**TOPOGRAPHIC SURVEY
SEASPECT SHORT PLAT
JOHN KAHAN**

NO.	DESCRIPTION	DATE
3	PERMIT REVISION	04.19.22
4	PERMIT REVISION 2	06.10.22
5	PERMIT REVISION 3	08.30.22

CLARKSON RESIDENCE
8163 W MERCER WAY
 City of Mercer Island, Washington

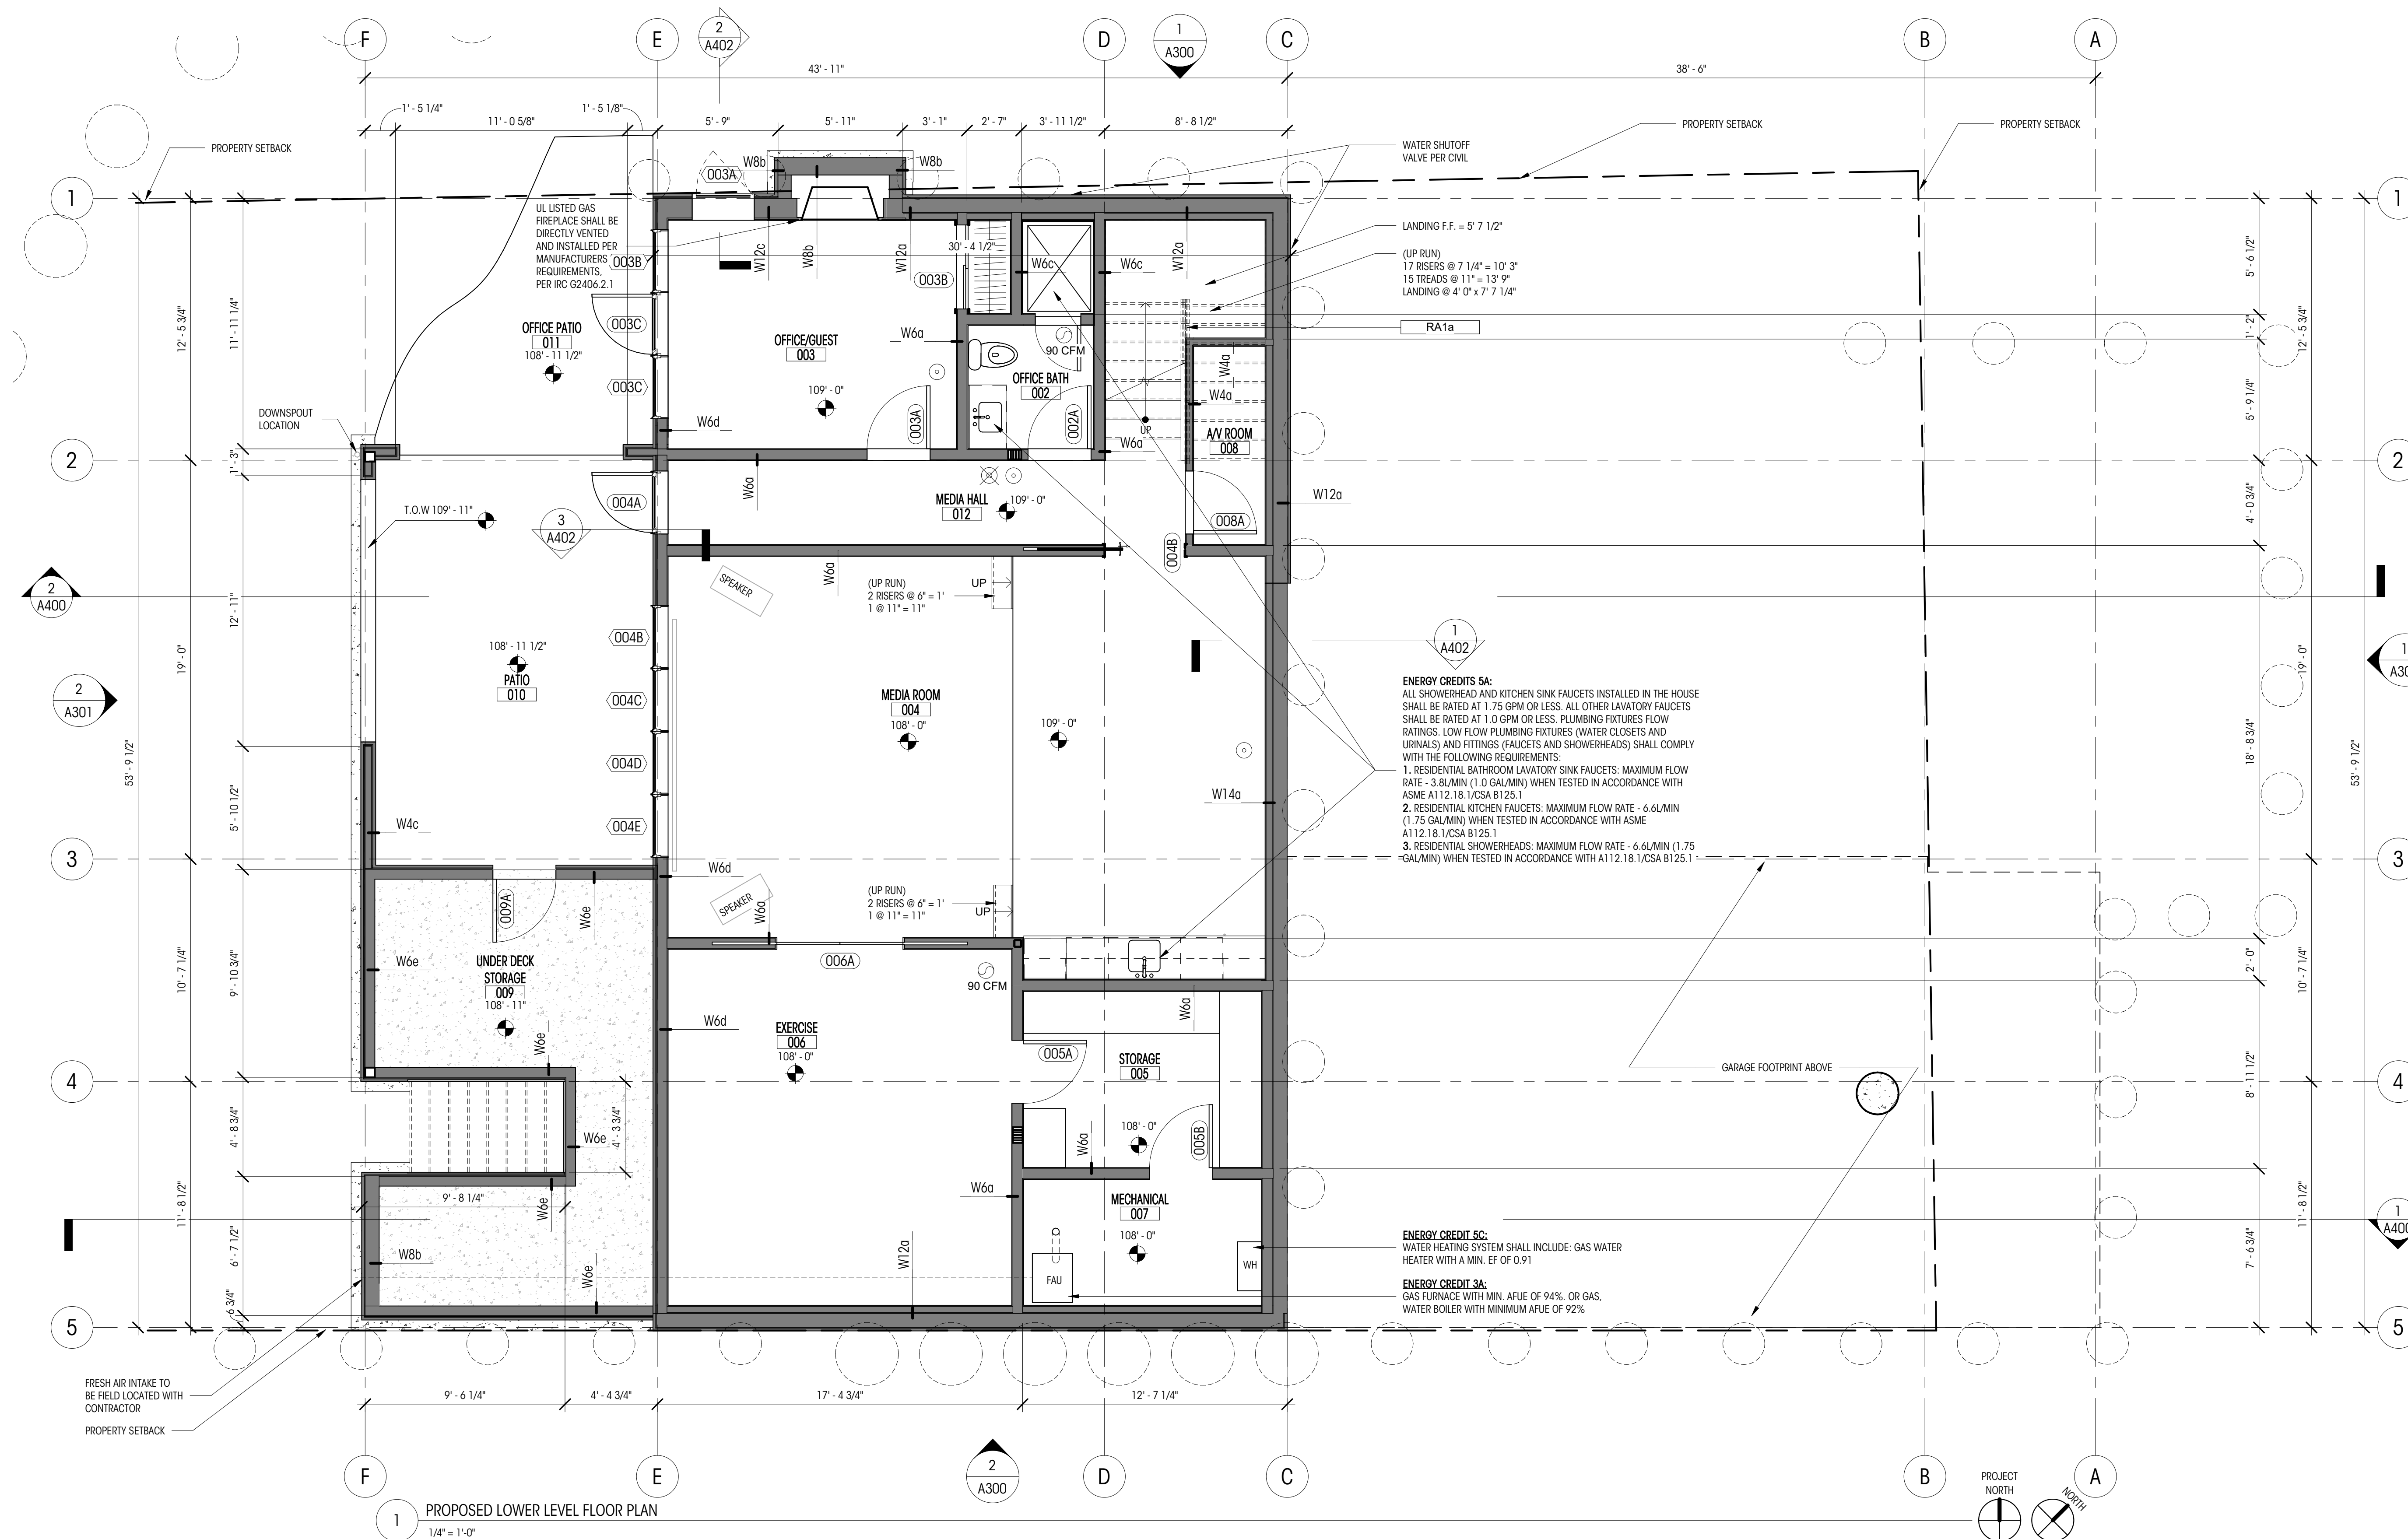
- NON-STRUCTURAL INTERIOR LAYOUT CHANGES TO BASEMENT LEVEL.
- ADDITION OF FIREPLACE AT BASEMENT LEVEL.
- ADDITION OF PATIO AT BASEMENT LEVEL.
- WINDOW SIZE & LOCATION CHANGES.
- EXTENDED WESTERN PATIO TO THE NORTH AND SOUTH
- LEVEL CHANGES: DRIVEWAY & GARAGE LEVEL DROP BY 12\"/>

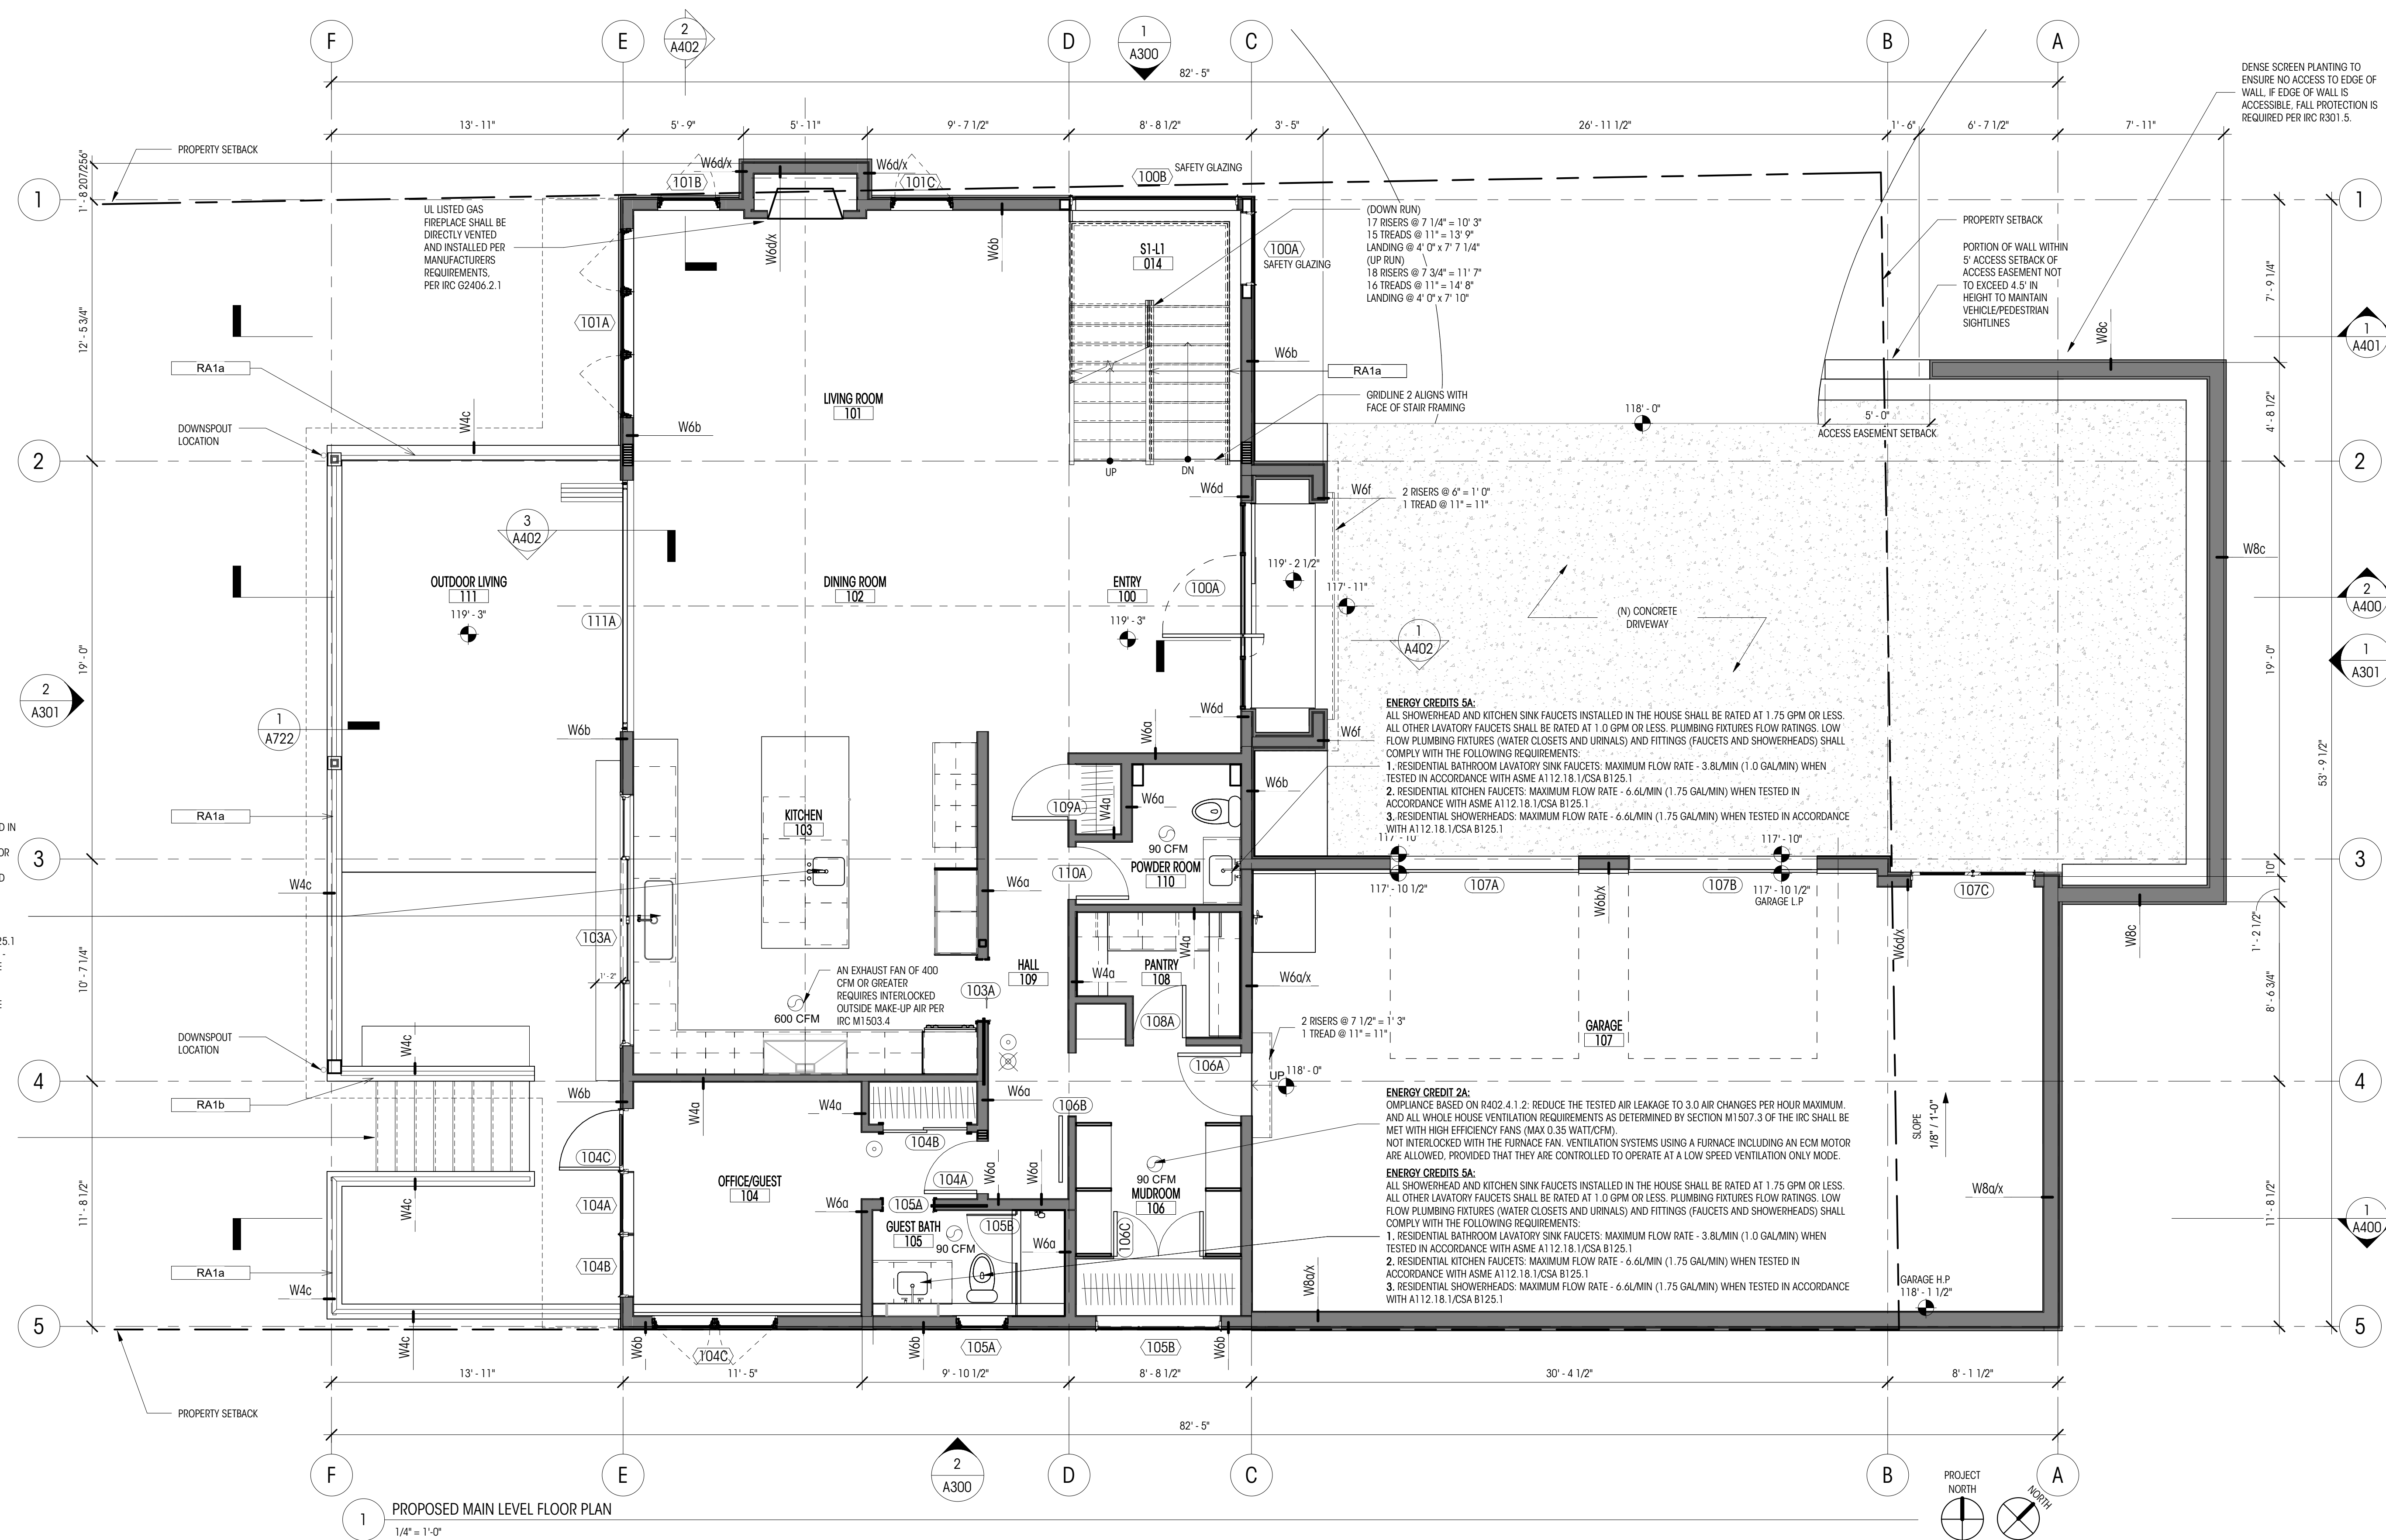
- INTERIOR LAYOUT CHANGES TO MAIN LEVEL
- ENTRY DESIGN CHANGE
- WINDOW SIZE & LOCATION CHANGES
- EXTENDED WESTERN PATIO TO THE NORTH AND SOUTH
- LEVEL CHANGES: DRIVEWAY & GARAGE LEVEL DROP BY 12"
- SHIFT OF PARKING RETAINING WALLS TO NORTH AND SOUTH
- EXTEND GARAGE EAST INTO FRONT YARD SETBACK AS ALLOWED BY CODE 19.02.040.D

1 PROPOSED UPPER LEVEL FLOOR PLAN
1/4" = 1'-0"

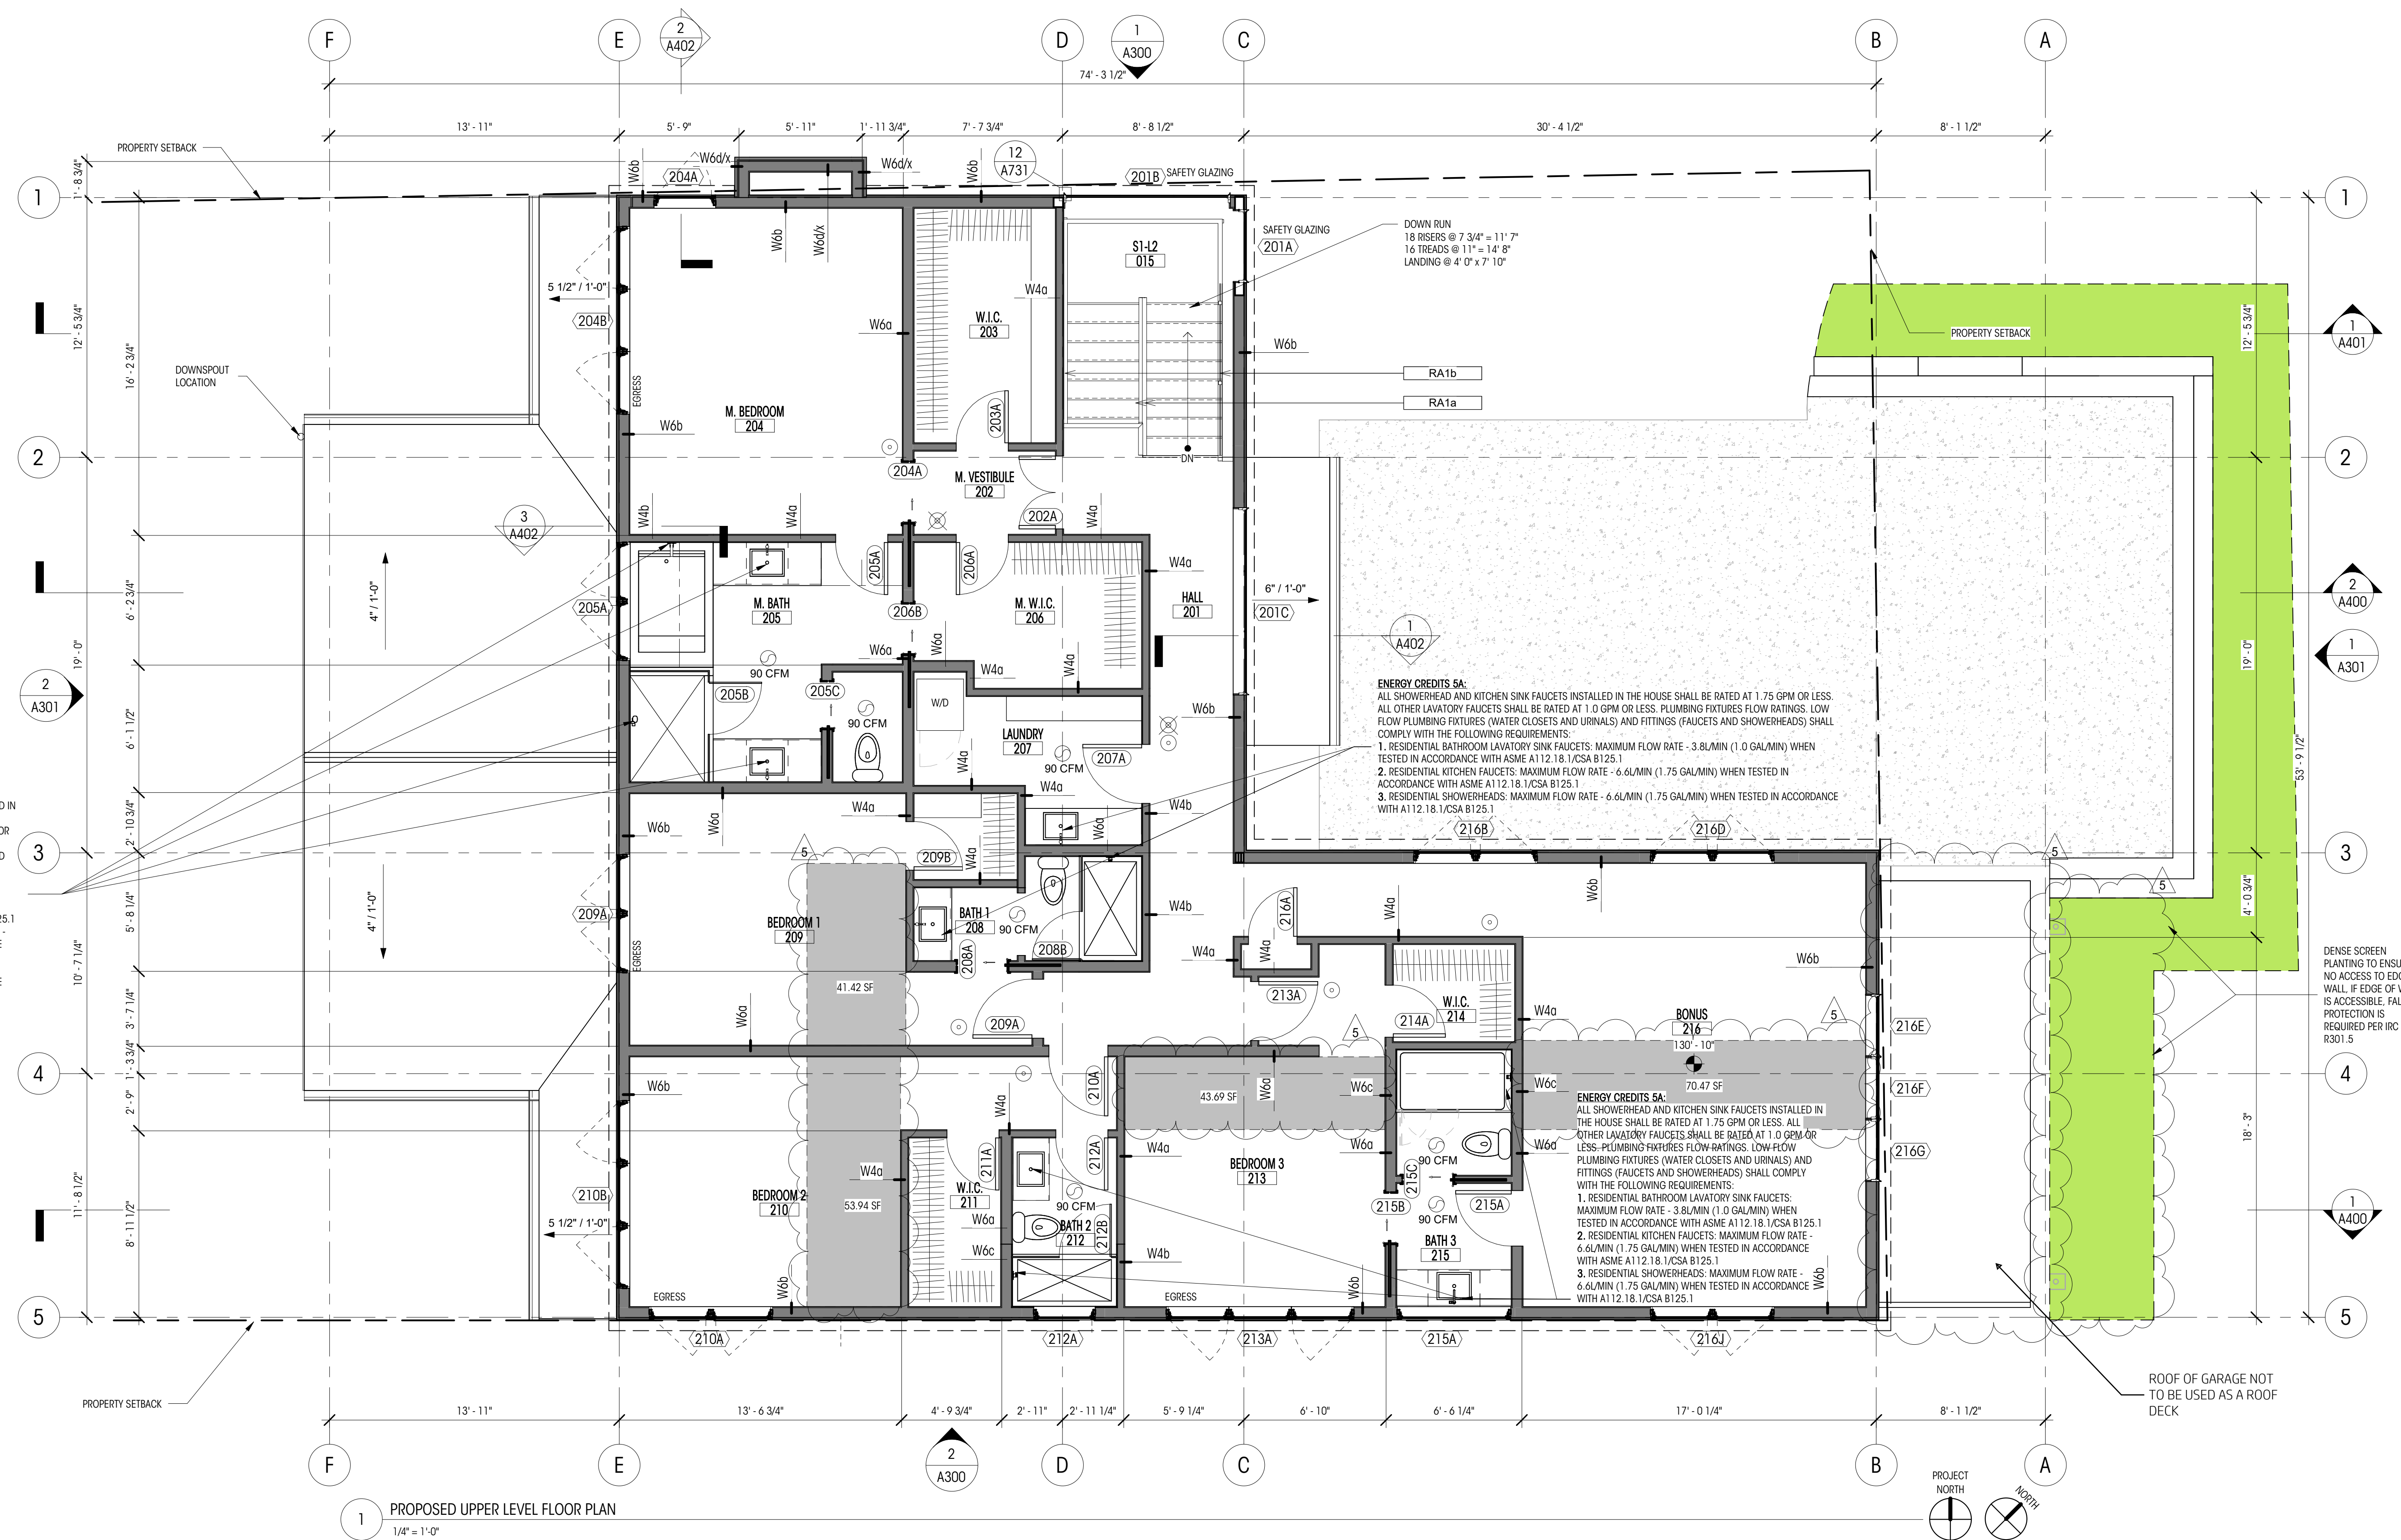
- INTERIOR LAYOUT CHANGES TO UPPER LEVEL.
- WINDOW SIZE & LOCATION CHANGES.
- EXTENDED WESTERN PATIO TO THE NORTH AND SOUTH.
- ELIMINATION OF UPPER LEVEL DECK, MAIN FLOOR DECK TO RECEIVE STANDARD GABLE ROOF.
- ADDED DORMERS AT UPPER LEVEL BONUS ROOM.
- OMISSION OF FIREPLACE AT UPPER LEVEL.
- SHIFT OF PARKING RETAINING WALLS TO NORTH AND SOUTH.
- ADDITION OF AWNING ROOFS OVER OFFICE & LIVING ROOM.
- EXTEND GARAGE EAST INTO FRONT YARD SETBACK AS ALLOWED BY CODE 19.02.040.D
- ADDED DECK AT ROOF OF THE EXTENDED GARAGE AREA.
- BATHROOM REVISIONS RESULT IN 1 ADDITIONAL TOILET AND 1 ADDITIONAL SHOWER
